16-BIT MICROCONTROLLER STARTERKIT
SK-16FX-144PMC-USB

FUNCTIONAL LIMITATION
USB FUNCTION INTERFACE

CUSTOMER INFORMATION

5.2 Design modification V1.1

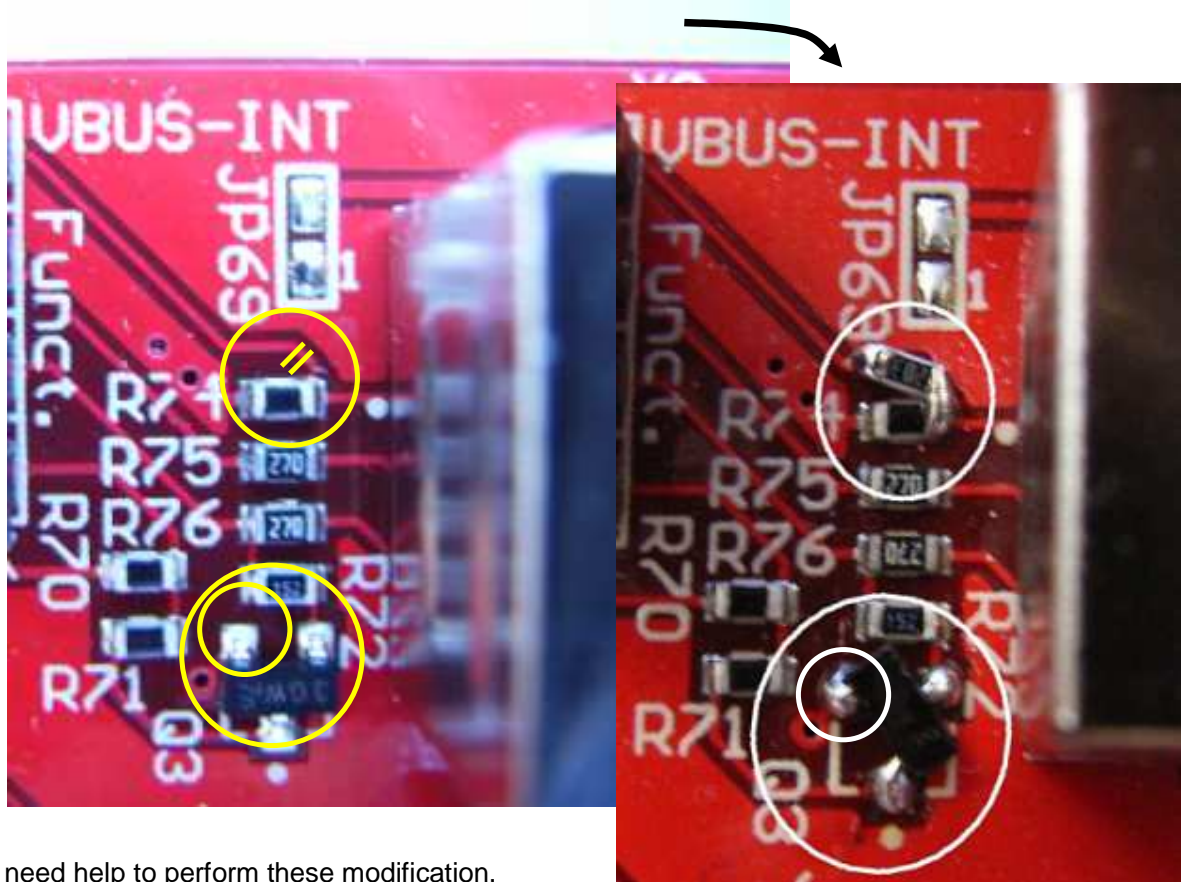
- In case that the SK-16FX-144PMC-USB is not self powered but connected to an USB Host, an increased current may be driven via VBUS of the USB Function interface X3 connected to the microcontroller's interrupt input.
- Even when Vbus is not yet detected the D+ pull up resistor is enabled.
- Even when HCONX jumper JP67 is open, D+ pull up resistor is enabled

The problem is caused by PCB design error.

The problem can be fixed manually as follows:

1. Cut the trace from X3-1 to JP64-1 (VBUS) as shown close to R74
2. Solder an additional resistor R99=20kOhm between X3-1 and JP64-1 (VBUS)
3. Remove (desolder) Q3 carefully
4. Put Q3 backward on top and solder Q3 again as shown
Keep the position of the marked pin close to R71 (Emitter)

5.3 Use SK-16FX-144PMC-USB V1.1 or newer

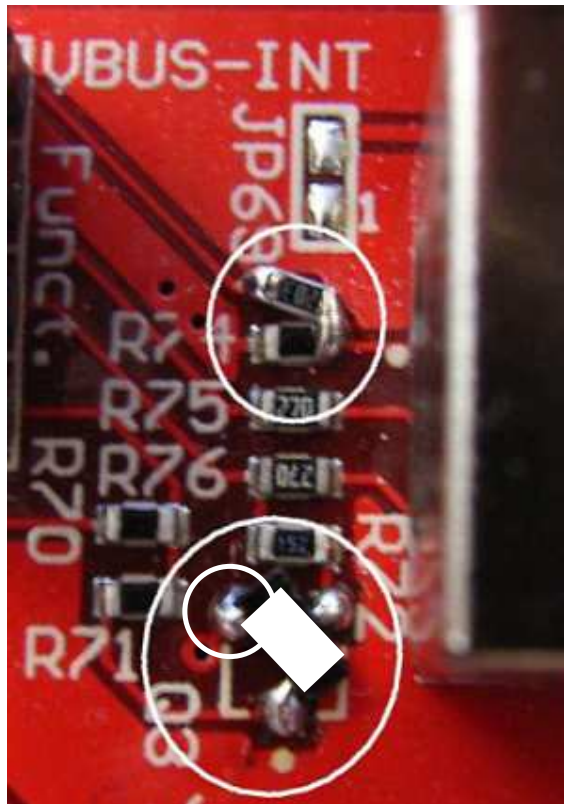
After patching to V1.1 some boards were assembled with the wrong type of transistor (NPN instead of PNP) for Q3.

The SK-16FX-144PMC-USB revision V1.1 or newer have the bug fix already included. On some boards the wrong type of transistors were assembled. If the function mode has problems after resetting the MCU to be recognized by the host, this can be an indication for the wrong type of transistor. Repaired boards have a white mark on the transistor.

The problem can be fixed manually as follows:

1. Remove (desolder) Q3 carefully
2. Put a new BC857C **PNP** transistor backward on top and solder it as shown
Keep the position of the marked pin close to R71 (Emitter)
3. Mark the transistor Q3 to discover that the board was fixed.
